REFERENCE: P/20/756/FUL

LOCATION: 31 Fulmar Road, Porthcawl CF36 3PN

**PROPOSAL:** Remodelling of bungalow to provide first floor accommodation by

demolishing existing garage, constructing two storey extensions to either side of the existing dwelling incorporating new integral garage

**Existing Ground Floor Plan**

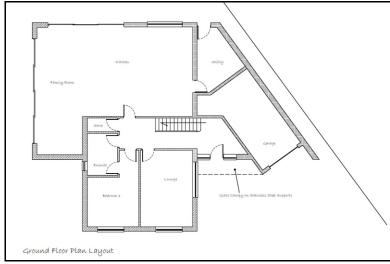
- Built up to the boundary with number 33 Fulmar Road

The mass and scale of the proposed development is overbearing and not in keeping with the neighbouring properties. The gable wall shown on the boundary is not buildable or maintainable without permission from the neighbours to place foundation footings within their property.

The extension has been reduced in width and is now proposed to be set in from the boundary with 33 Fulmar Road by 1.35 metres. The objection raised is therefore considered to be addressed through the submission of amended plans.

Application Site OS Map

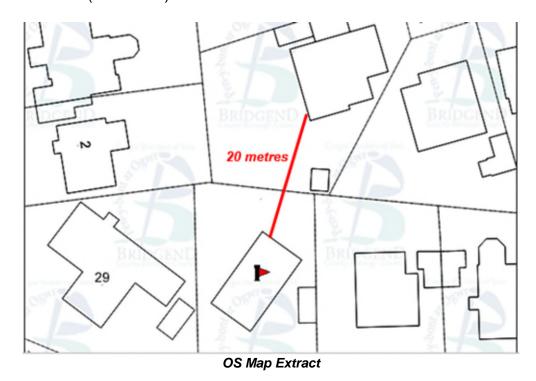
Whilst few gardens are entirely private, some features can cause unacceptable levels of over dominance and overlooking. The objections raised by the occupiers of 29 Fulmar Road, 33 Fulmar Road and 2 Sandpiper Road relate to privacy and generally refer to the lack of distance provided between the extended property and the existing properties resulting in a loss of privacy for neighbouring occupiers.

Paragraph 4.6.2 of SPG02 stipulates that the minimum distance between directly facing habitable room windows...should normally be 21 metres but reductions may be acceptable where a permanent screening can be provided between facing ground floor windows.

There are four roof lights proposed to be installed on the rear north easterly facing roof slope. The windows will serve two of the ensuite bathrooms and bedroom four. Note 6 of SPG02 advises that the minimum distance between directly facing habitable room windows in adjacent properties should normally be 21 metres. In this instance, the distance currently provided between the dwelling and the property known as 10 Teal Close is 20 metres (see below):

In addition, paragraph 4.6.3 of SPG02 states that to reduce the loss of privacy, it is recommended that the minimum distance from the new habitable room window to the boundary should be 10.5 metres. The existing property lies 7.2 metres away from the northern boundary.

It is considered that the introduction of roof lights would not overlook the garden and property to the north to the extent which would warrant a refusal on such grounds. The OS Map Extract demonstrates that the property to the north, known as 10 Teal Close, is orientated principally to face east and west and as such any windows in the southern elevation of the property are secondary windows.

To ensure that the introduction of roof lights is not detrimental to the privacy and amenity of the occupiers of the property to the north, it is considered reasonable to impose a Planning condition which requires the roof lights to be relocated in the roof slope to prevent any form of direct overlooking when an occupier is stood within the roofspace. The roof lights should be positioned within the roof slope above the eye line of the occupiers to prevent overlooking.
